ADDENDUM NO. 1  
SEWERAGE SYSTEM IMPROVEMENTS  
CONTRACT 16-01  
PEAK WASTEWATER FLOW DIVERSION  
PUMPING STATION MODIFICATIONS  
CLEVELAND UTILITIES  
CLEVELAND, TENNESSEE  
CU PROJECT NO. S2683X  
WAUFORD PROJECT NO. 4626

Date of Addendum: Wednesday, April 5, 2017

SHEET 3 OF 8

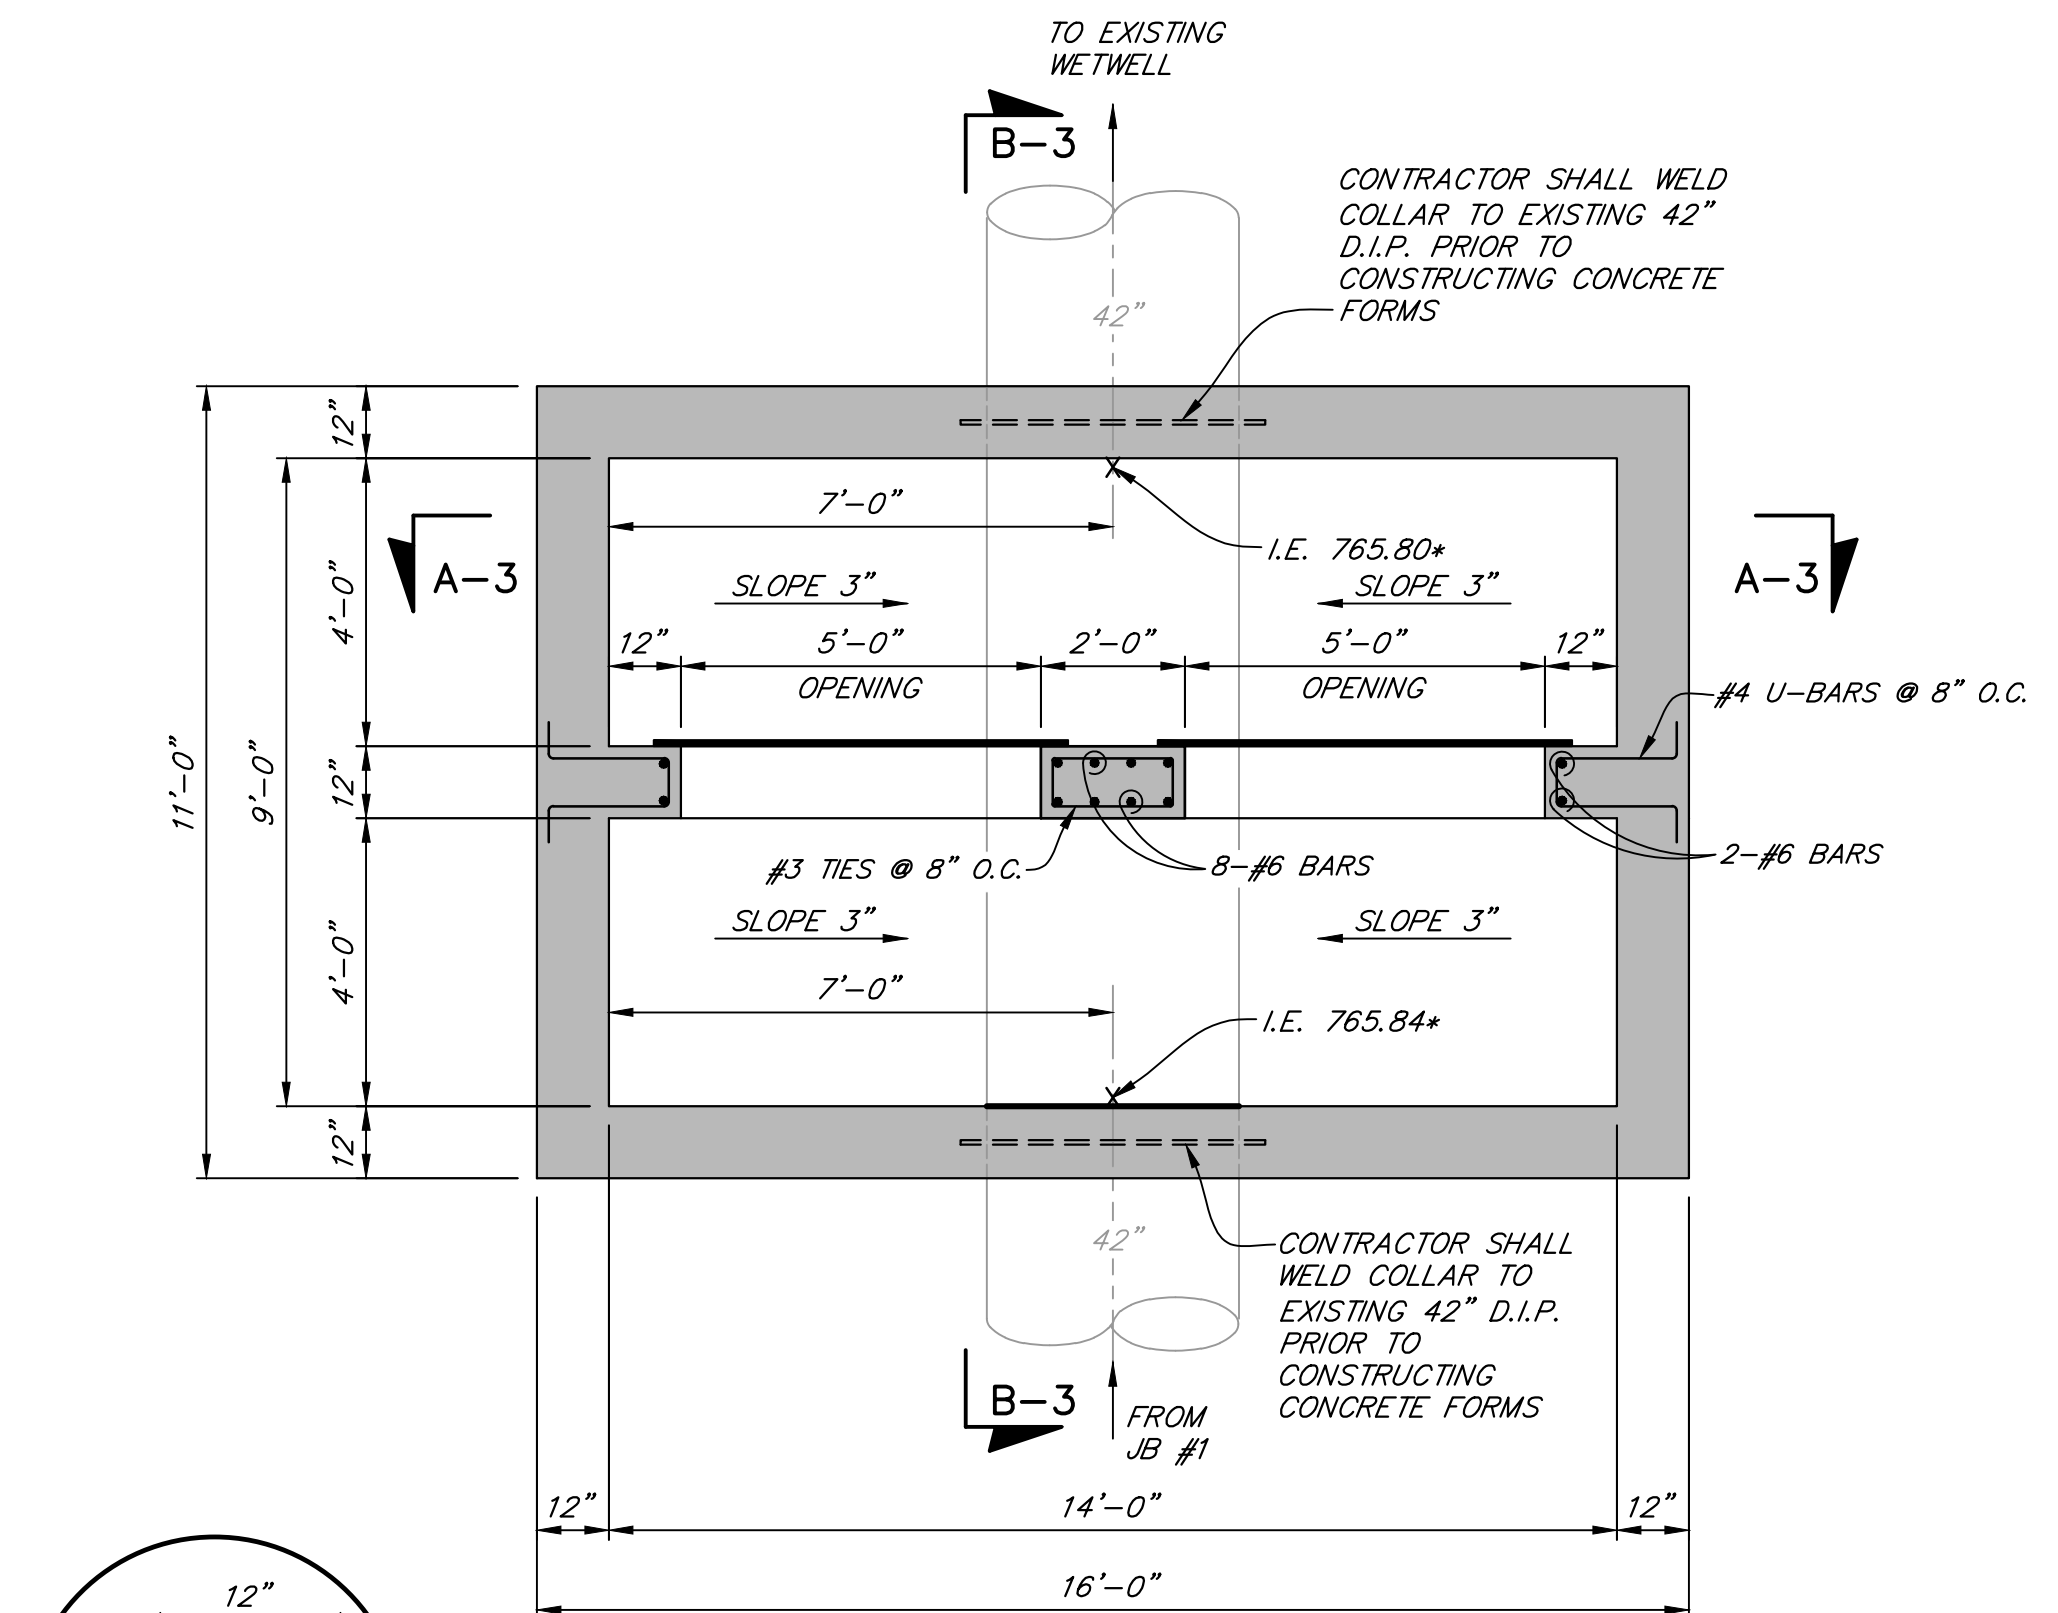
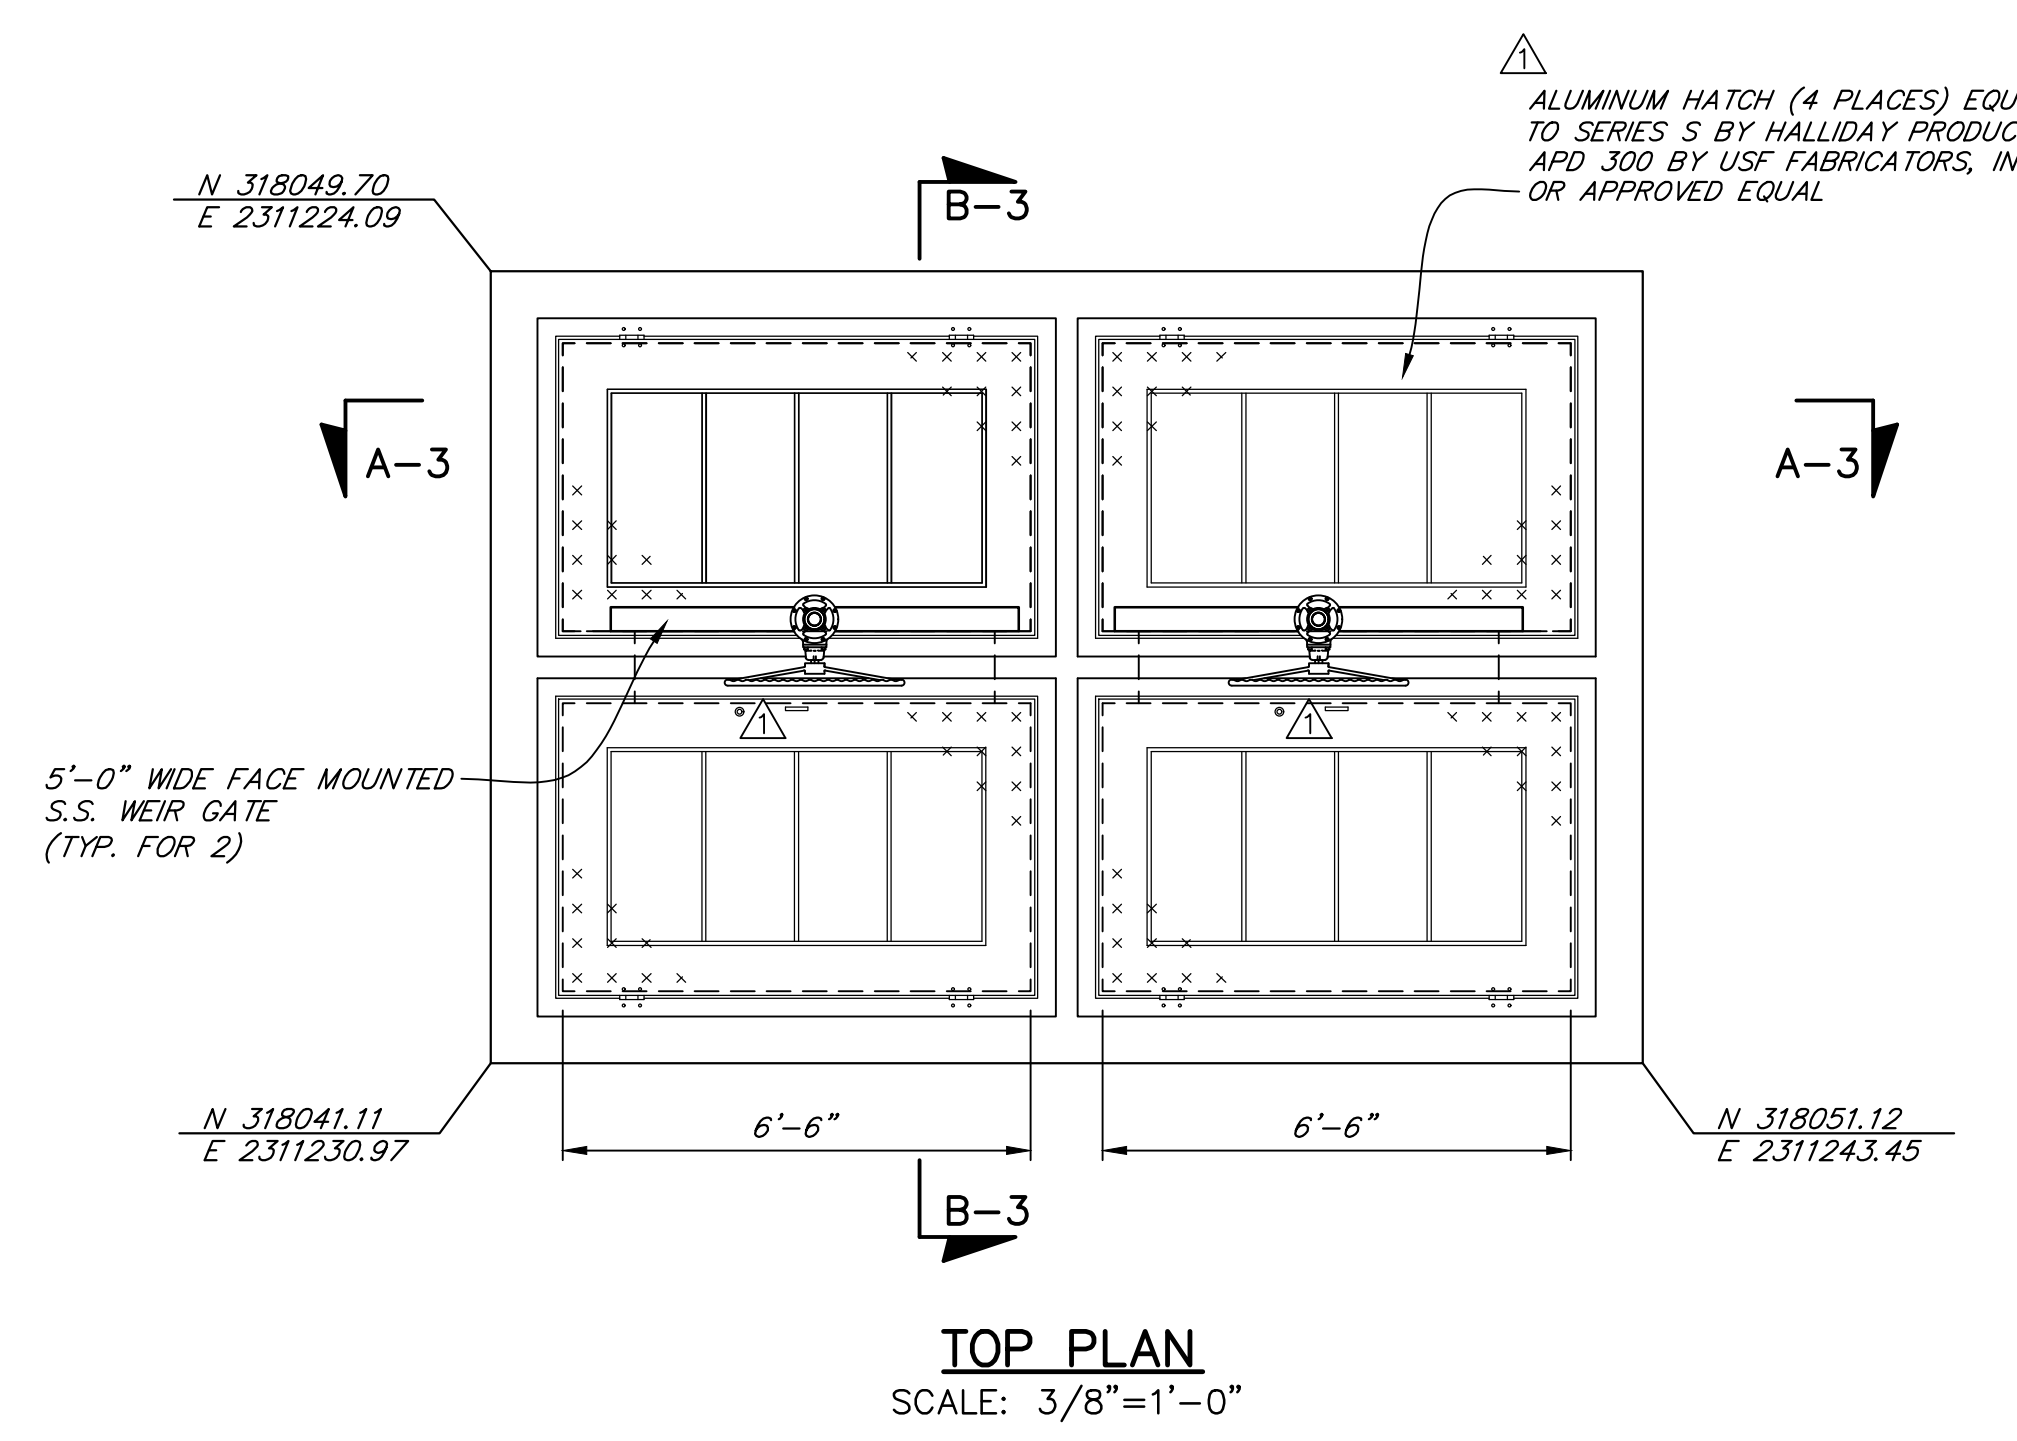
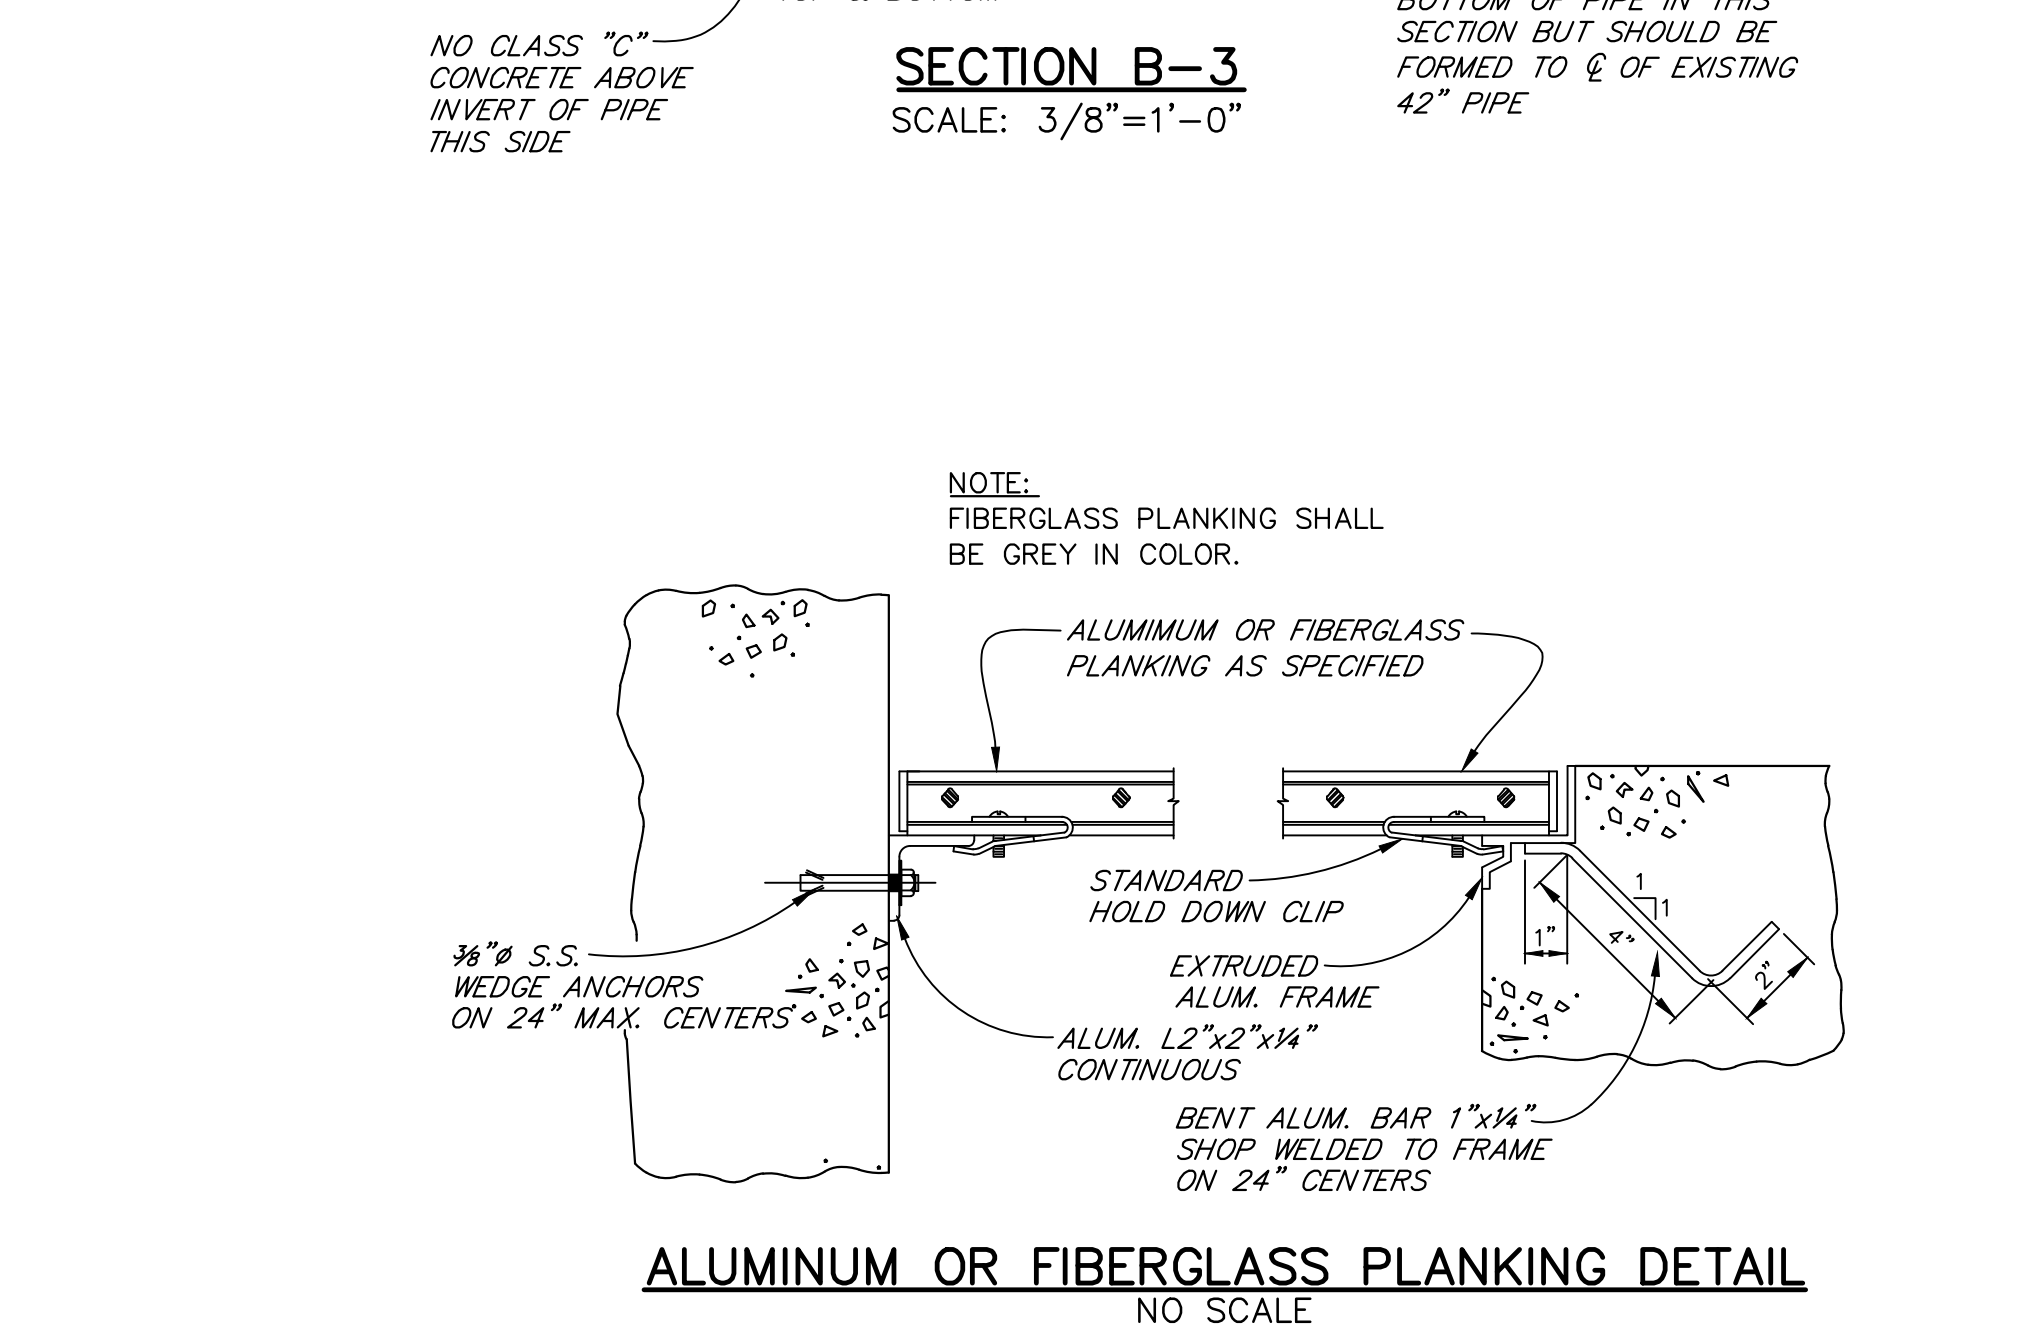
6. Plans, Sheet 1:  
Revise as shown on attached Plans, Sheet 1.
7. Plans, Sheet 2:  
Revise as shown on attached Plans, Sheet 2.
8. Plans, Sheet 3:  
Revise as shown on attached Plans, Sheet 3.
